SURVEYOR'S OFFICE
Hamilton County

RE: Beaver & Brooks Drain

RE: Beaver-Brooks Drain

Re: Beaver & Brooks Legal Drain
Mansur Corp. Reconstruction

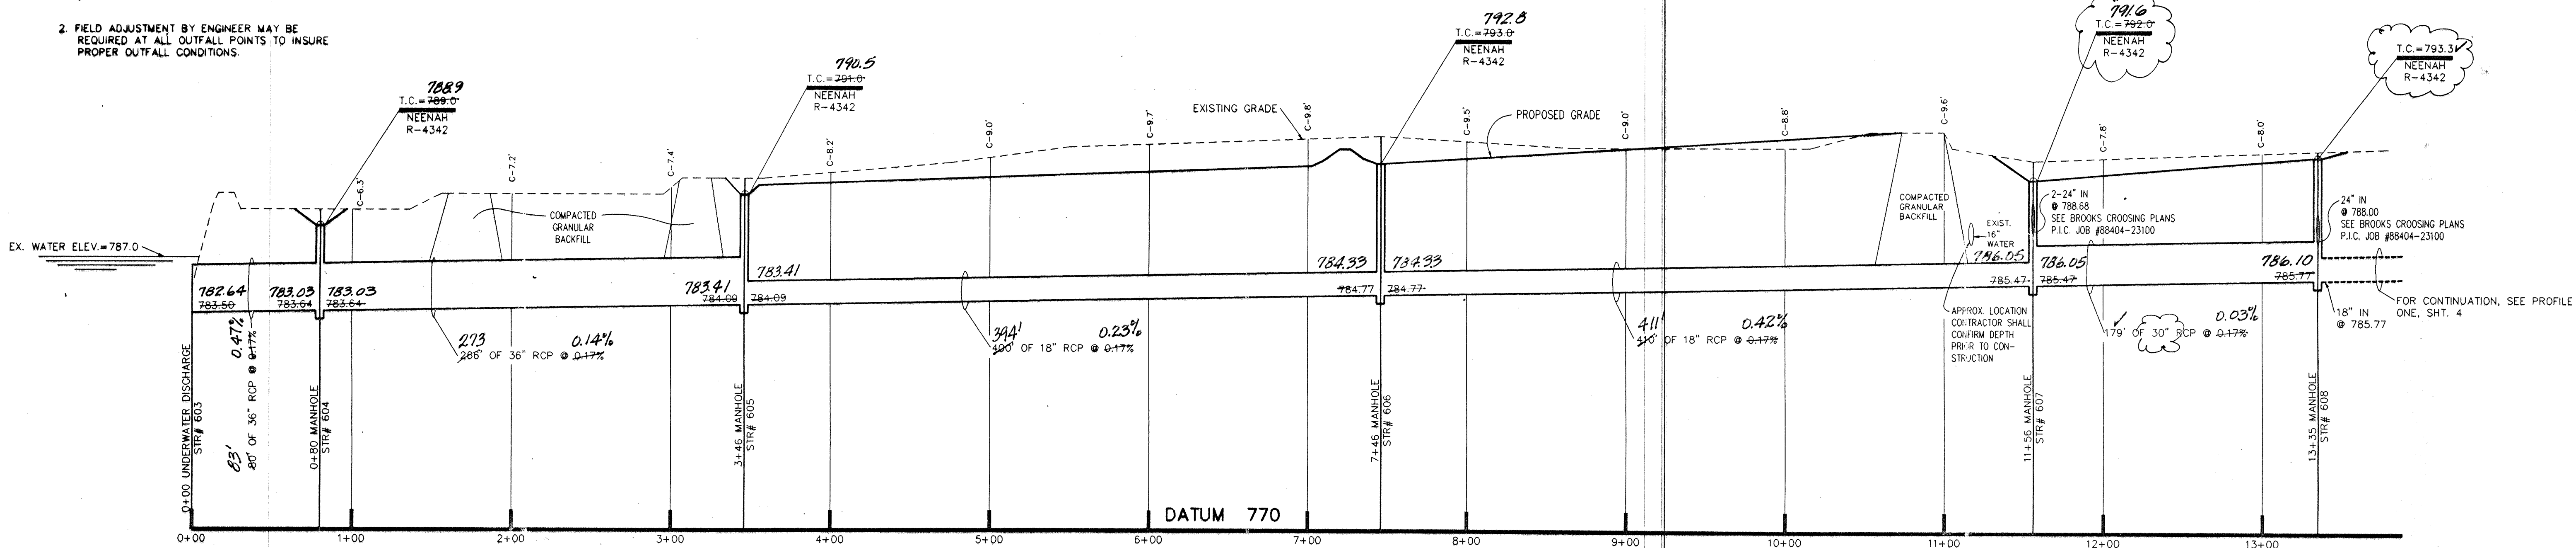
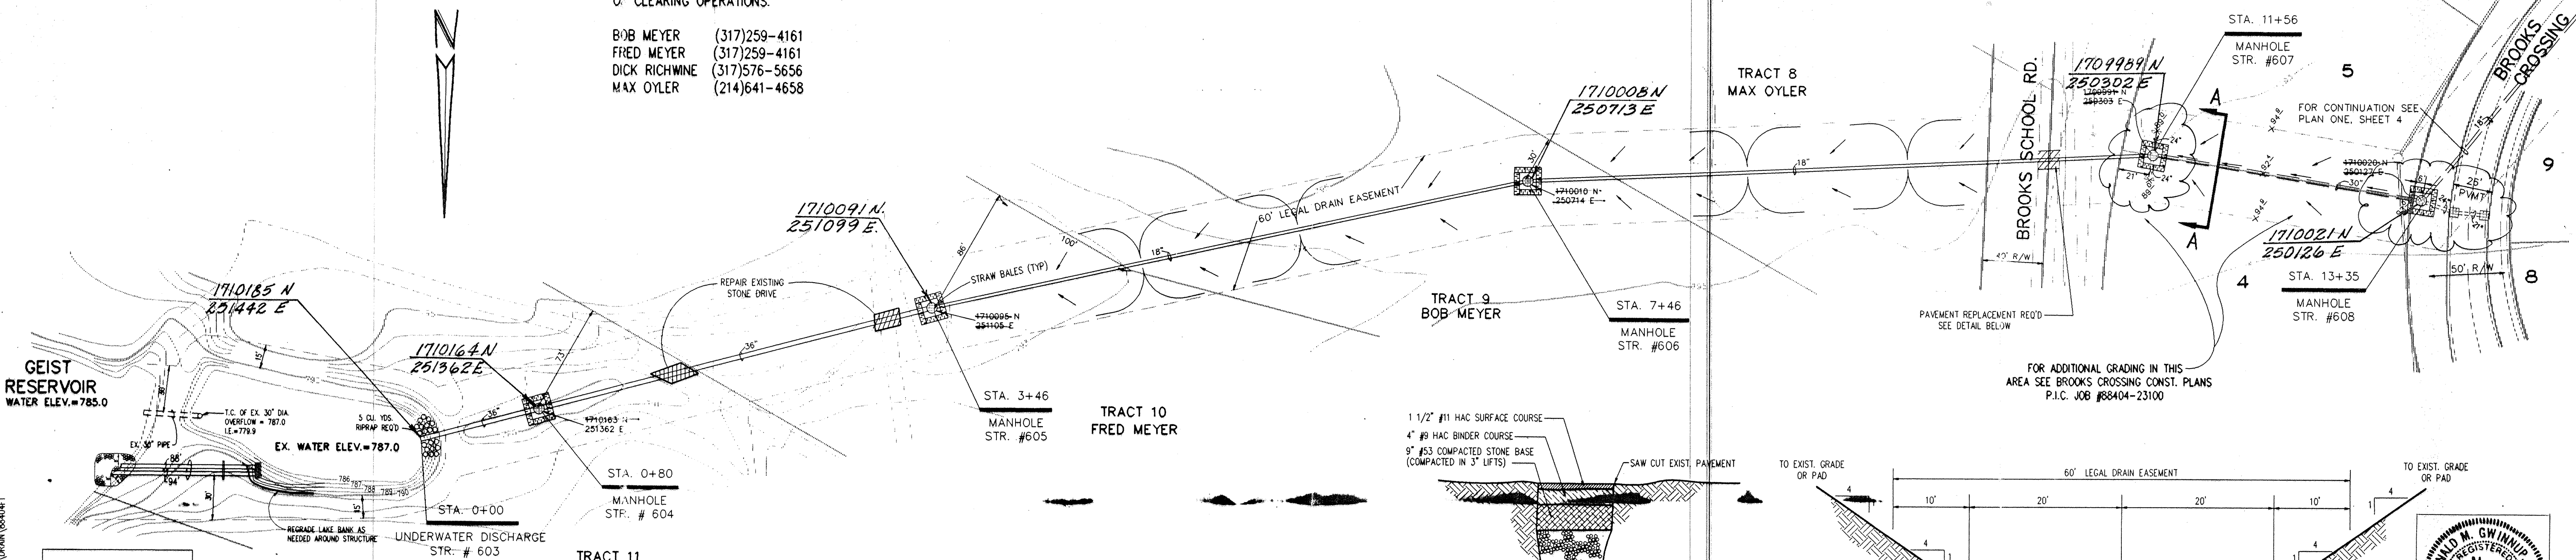
at or near STA 32+00 as per the 1897 Viewers Report. The new Storm sewer will then run as shown on Sheet 7 on the attached plan for 480 feet. (STR 615) and sheets 2,3,and 4 between STR 600 and 613.

The 36" RCP between Structures 603 and 604 was lengthened from 80' to 83'.
Structure 604 to 605 consists of 36" RCP which was lengthened from 266' to 273'.
Structure 605 to 606 consists of 18" RCP and was shortened from 400' to 394'.
Structure 606 to 607 was lengthened from 410' to 411'.
The RCP between Structure 607 and 608 was upgraded from 18" RCP to 30" RCP.
The 18" RCP between Structure 608 and 609 was lengthened from 205' to 206'.
Structure 651 is an additional structure that was placed between Str's 609 & 610.
This lengthened the 18" RCP from 398' to 408' total.
The 18" RCP between Str 610 to 611 & Str 611 to 612 was shortened from 390' to 381'.
Structure 613 to 614 consists of 18" RCP which was shortened from 155' to 153'.

DWG. TYPE	FILE NUMBER	SHEET:
		7
JOB NUMBER		of 9
8 8 4 0 4 1 - 2 6 7 0 0

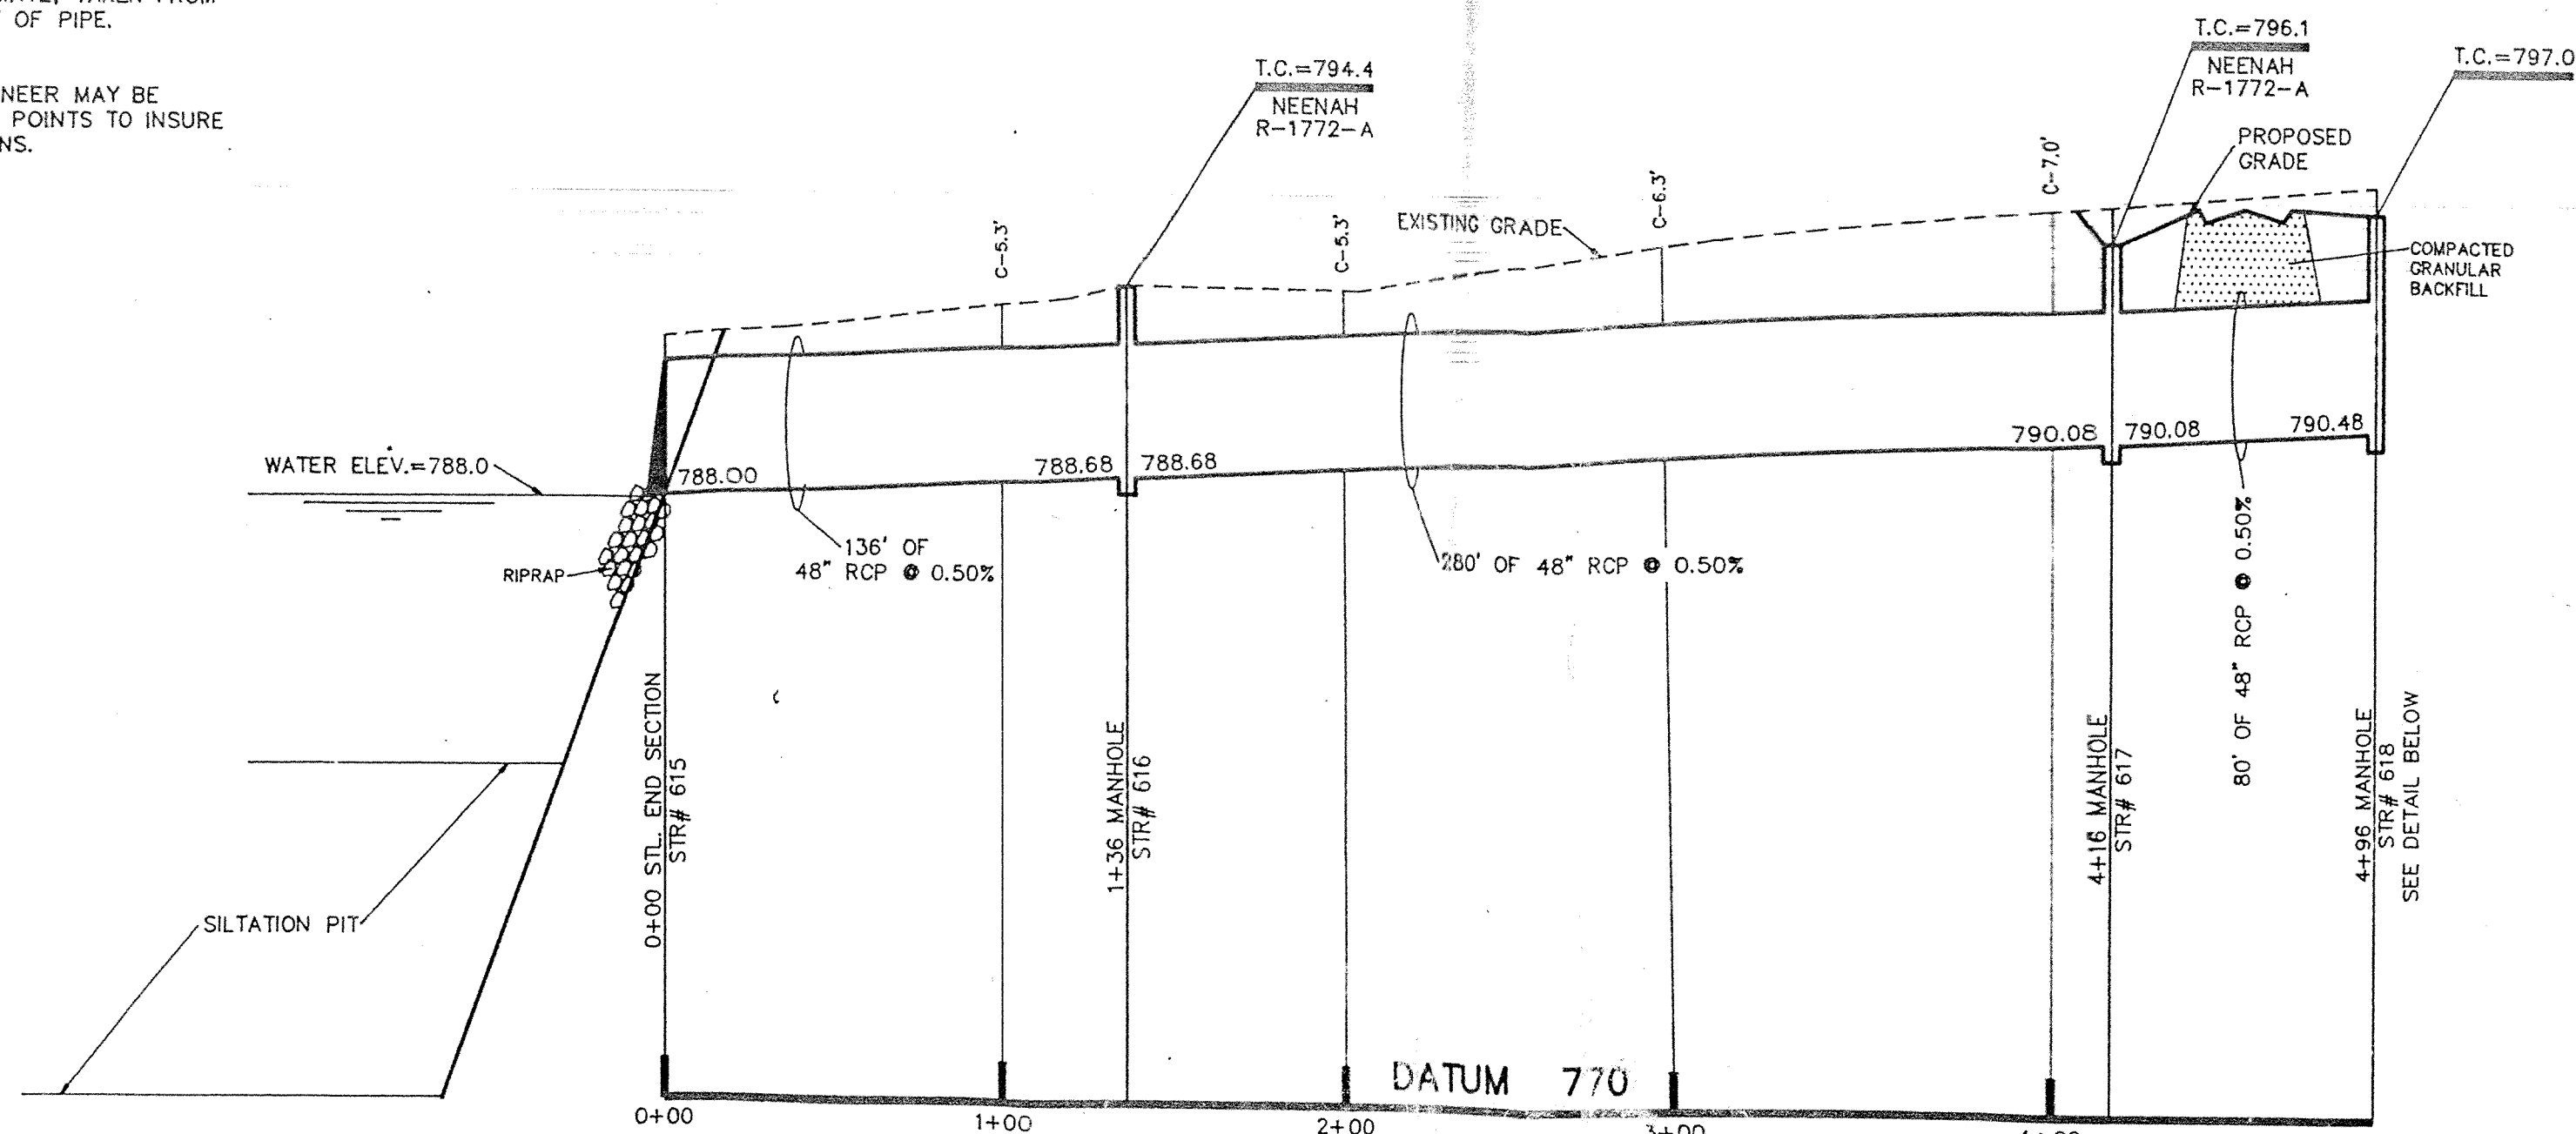
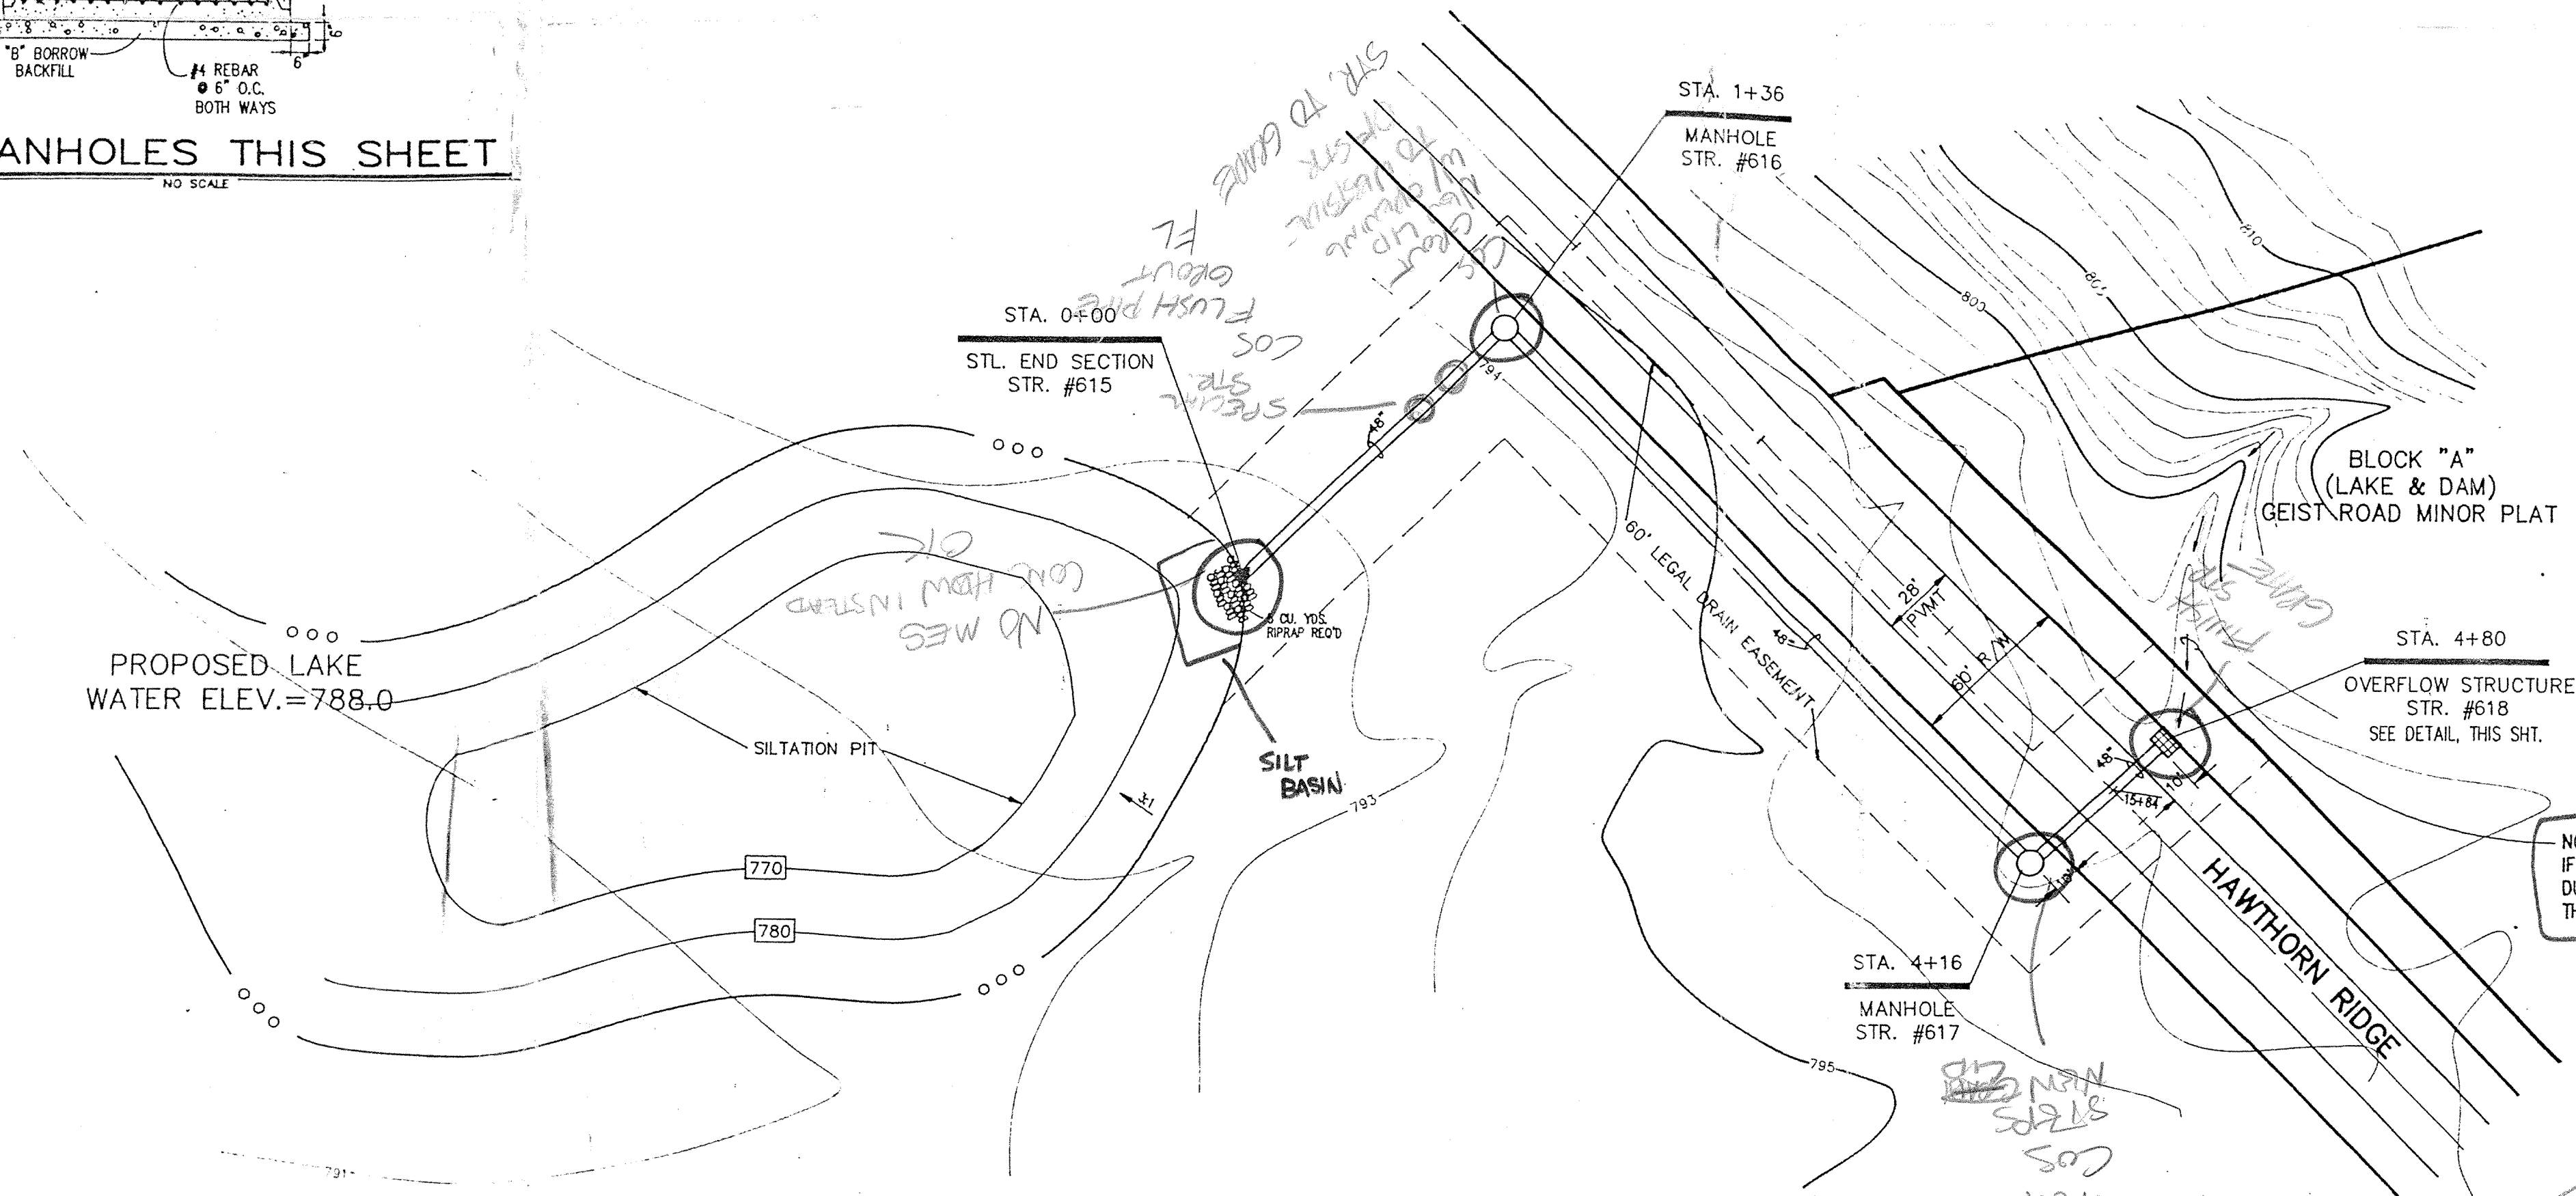
The proposed system will intercept(at STR. 618)The existing drain
